MIL "ON" DTC P2610

YEAR(S)	MODEL(S)	ADDITIONAL INFORMATION
2014 - 2015	Highlander

Some 2014 – 2015 model year Highlander vehicles may exhibit a MIL "ON" condition with Diagnostic Trouble Code (DTC) P2610 (ECM/PCM Engine Off Timer Performance) present. The Engine Control Module (ECM) logic has been modified to reduce the possibility of this condition. Please follow the Repair Procedure below to address this condition.

Figure 1: Location of Authorized Modifications Label on 2014-2015 Highlander

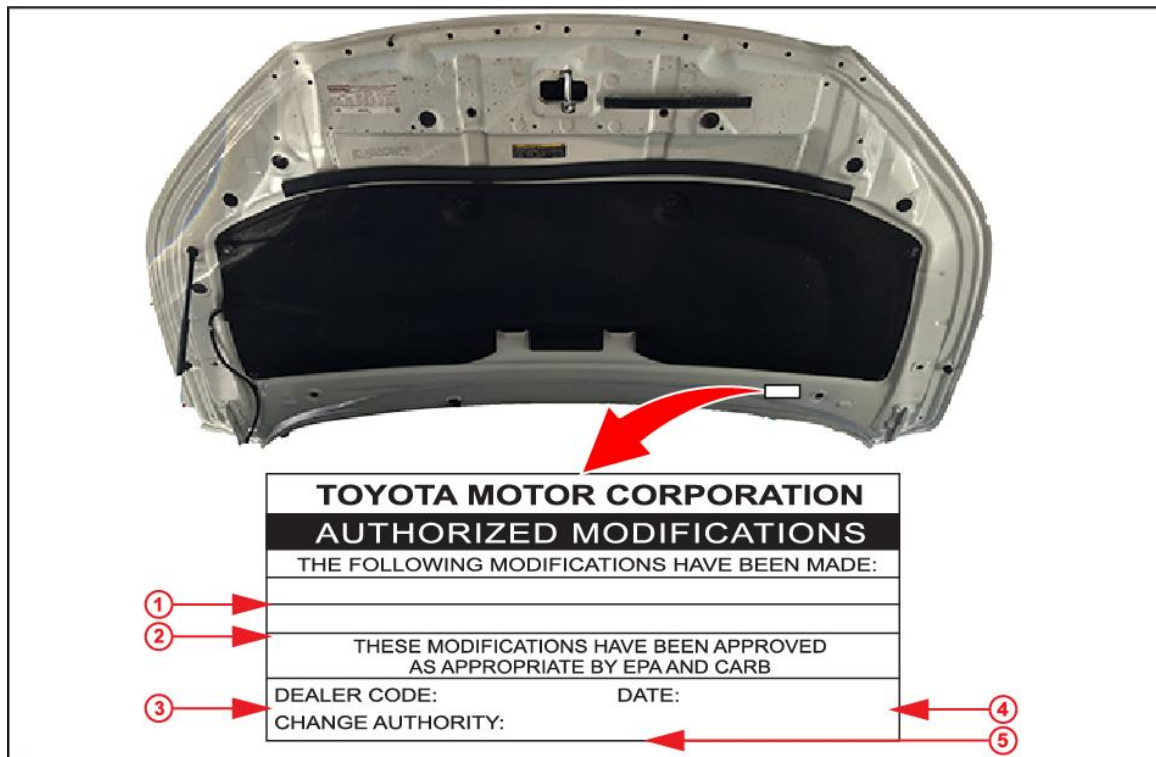
2. Check for the Authorized Modifications Label affixed to the vehicle in the location shown in Figure 1 below. Confirm if the ECM (PCM) calibration has been updated.

4. Install the Authorized Modifications Label.
 - A. Using a permanent marker, enter the following information on the label:
 - ECM part number [Refer to the **Parts Information** section for the **NEW PART NUMBER**]
 - Calibration ID(s) [Refer to the **Calibration Information** section for the **NEW CALIBRATION ID**]
 - Dealer Code
 - Repair Date
 - Change Authority [**This bulletin number**]
 - B. Affix the Authorized Modifications Label to the vehicle at the location shown in Figure 1.
The Authorized Modifications Label is available through the MDC, P/N 00451-00001-LBL.
5. Test drive the vehicle to confirm proper vehicle operation.
